STAFF REPORT: 9/11/2024 MEETING

ADDRESS: 1667 EDISON

APPLICATION NO: #HDC-2024-00493

SCOPE: REPLACE WINDOWS & REHABILITATE GARAGE

1667 Edison, designation slide, taken by the HDAB in 1974

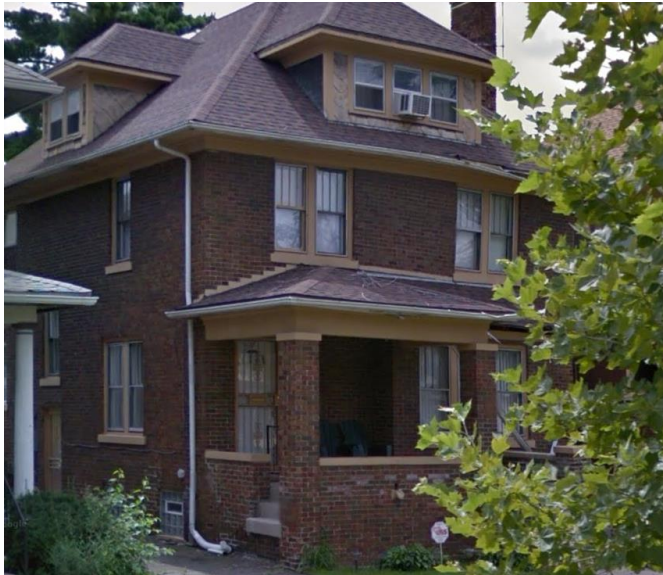
- To restate, the original wood window trim/brickmould does remain at all facades and at the rooftop dormers. The applicant has therefore submitted the current application in an attempt to resolve the outstanding window violation. As depicted in the photos below, the house's original windows were 4/1, wood-sash, double-hung units and 4-lite wood casement units. All window muntins were vertically oriented. It is staff's opinion that the original windows were distinctive, character-defining features of the house. Staff supports the proposed new window sash installation at the front façade as it will closely match the original windows which were removed in operation, material, and design and the original wood brickmould will be retained. However, because the new 1/1 and single lite sash proposed for installation at the side and rear walls do match the original character-defining units in design/lite configuration, it is staff's opinion that they do not meet the Standards.
